2023 - First Quarter
Potential Scribner Errors for Consideration

Potential Ordinance Revisions for Consideration

Potential Official Zoning Map Revisions

Zoning Map Amendmends Detail (Draft For Review - March 2023)

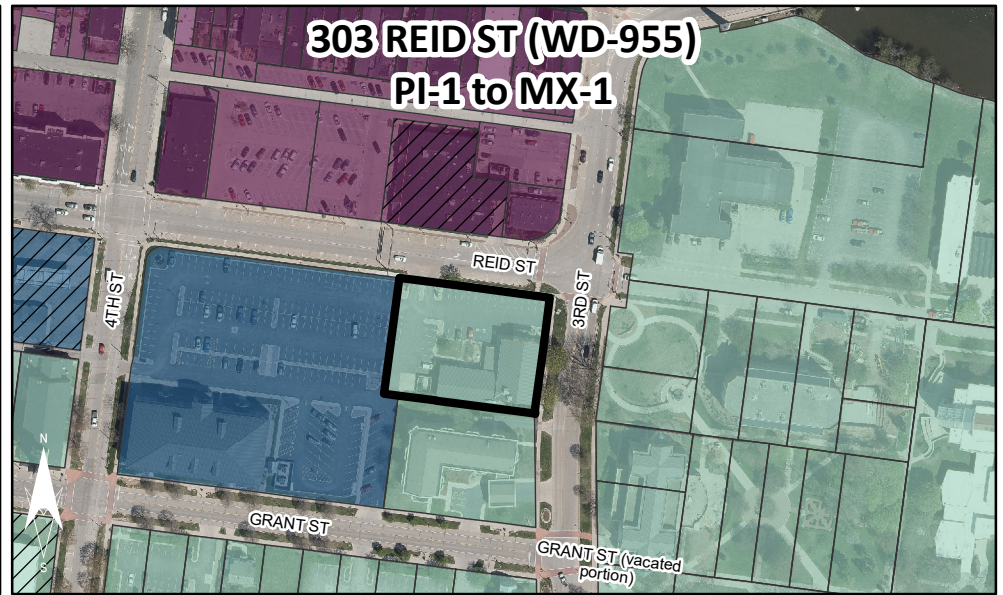
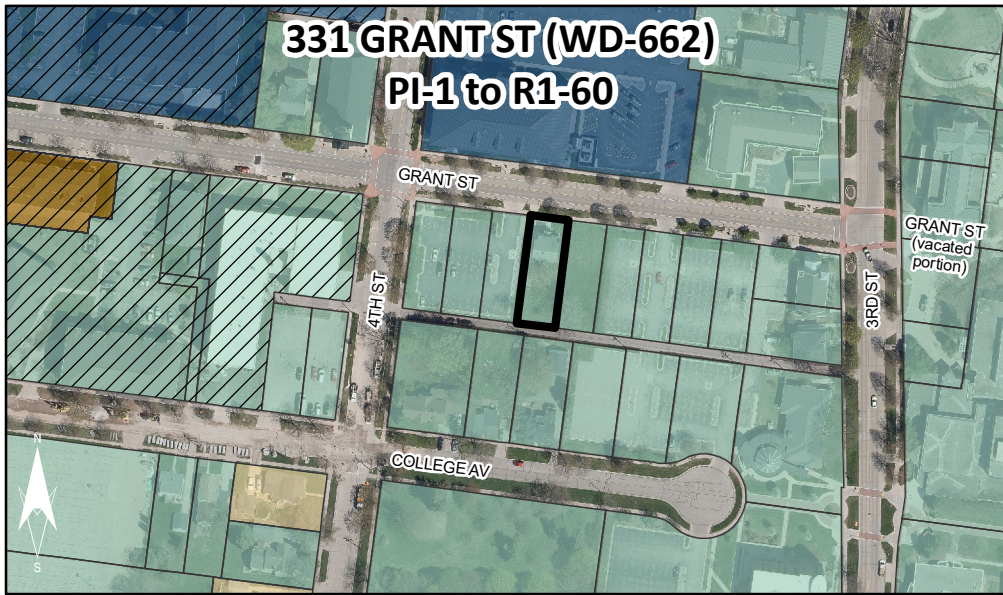
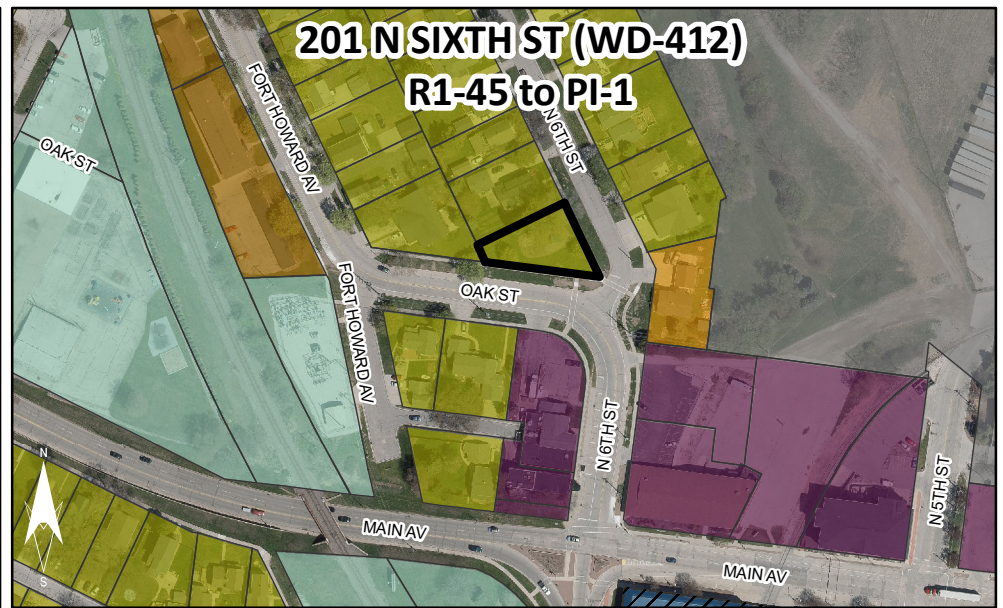
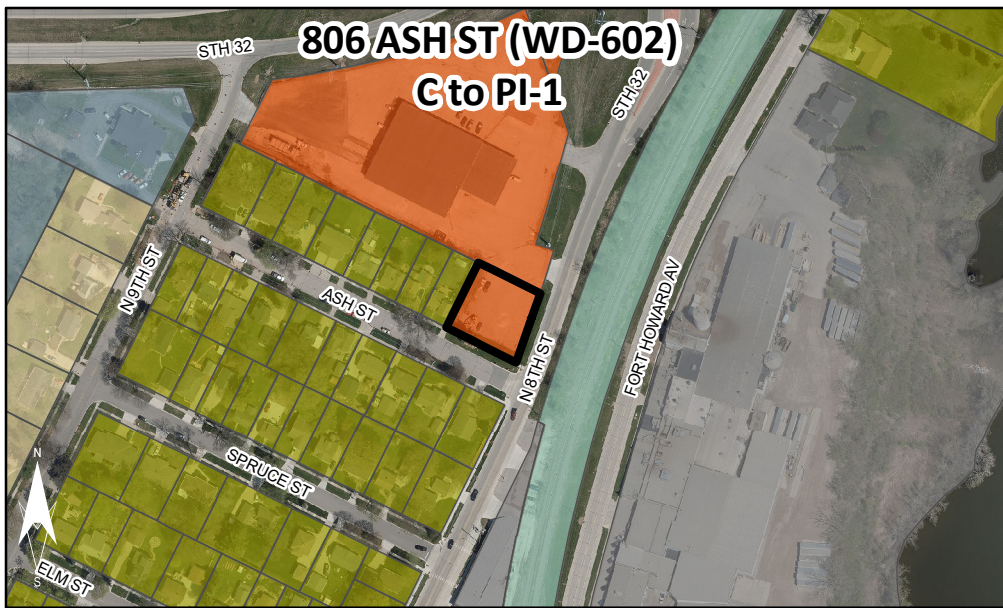
10-6	Add new 14-106(8)	(8) Transitional Yard Areas -- Additional landscaping or fence are required to provide visual screening when O, C, BP, and I districts abut residential zoning districts. Transitional yard area requirements include all of the following: (a) A landscaped area that is a minimum of 50 feet wide that is parallel to the residential district (unpaved and without buildings). (2) A minimum 6 foot tall berm that is parallel to the residential district. (3) Trees planted every 35 feet the full length of the landscaped area, on top of the berm. (4) Storm water management features may be placed within a transitional yard area.	
Article XI Signs			
11-5	14-111 Table 11-1	Add new "Directional (wall)" category as permitted with permit under BP-1, BP-2, and I. (Regulations added to Table 11-5 & Table 11-6 (details below).	
11-5	14-111 Table 11-1	Add Marquee as permitted with permit under ROW.
